R66 SERVICE BULLETIN SB-41B
(supersedes R66 Service Bulletin SB-41A)

DATE: 22 December 2022 **REV B:** 27 June 2024

SUBJECT: Tail Rotor Blade Inspection and Replacement

EFFECTIVITY: P/N F029-1 tail rotor blade S/Ns 3099 and prior (F029-1 REV F and prior).

SPECIAL TAIL ROTOR TIP PREFLIGHT INSPECTION

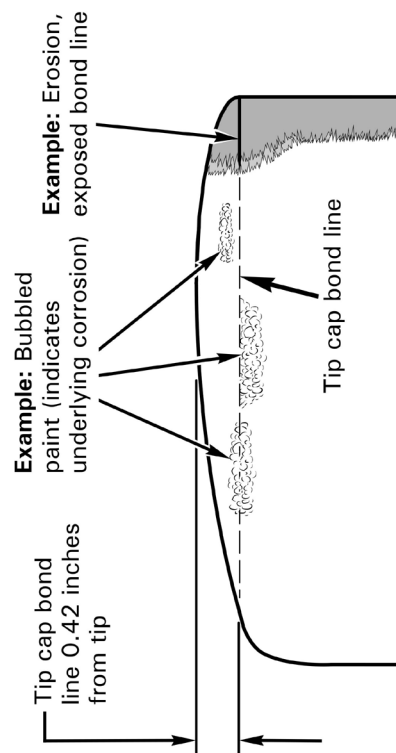
To be performed before the first flight of each day. May be performed by pilot or mechanic. Conduct visual inspection of tail rotor tip area. If bubbled paint or other evidence of corrosion is observed at or adjacent to tip cap bond line or if any portion of tip cap bond line is exposed, do not fly helicopter. Comply with latest revision of R66 SL-40 prior to further flight.
